V1_Drainage Letter_comments.pdf Markup Summary

Amo Acres Subdivision

Final Drainage Report

PCD File No: **SF2623**

24-in CMP Culvert (DP8 Q100 = 36.5 cfs)

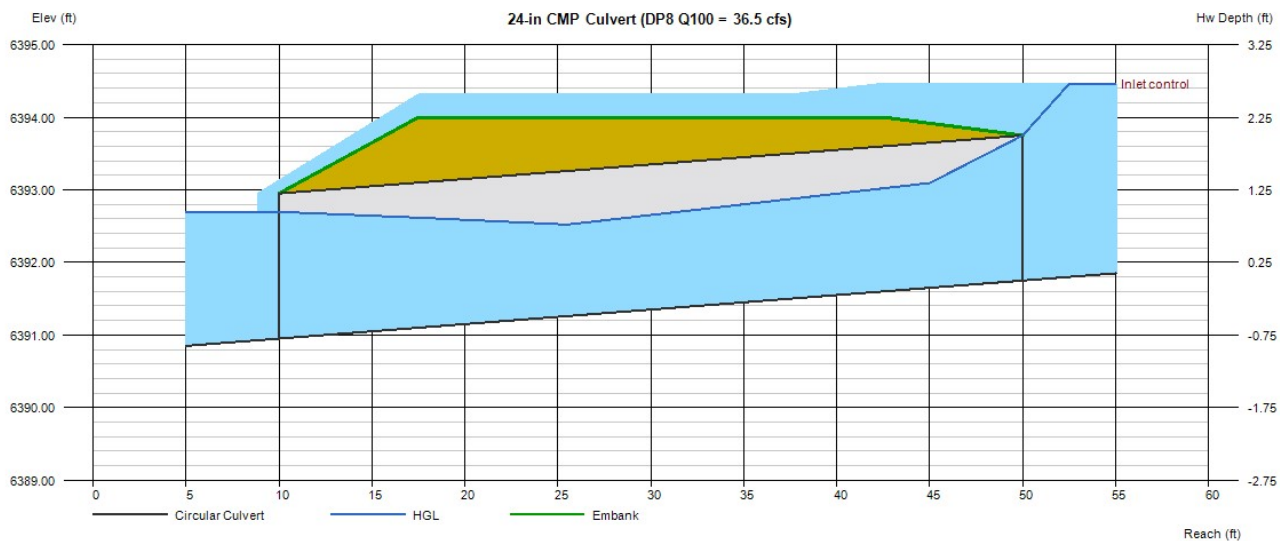
What are you going to do about this over topping?
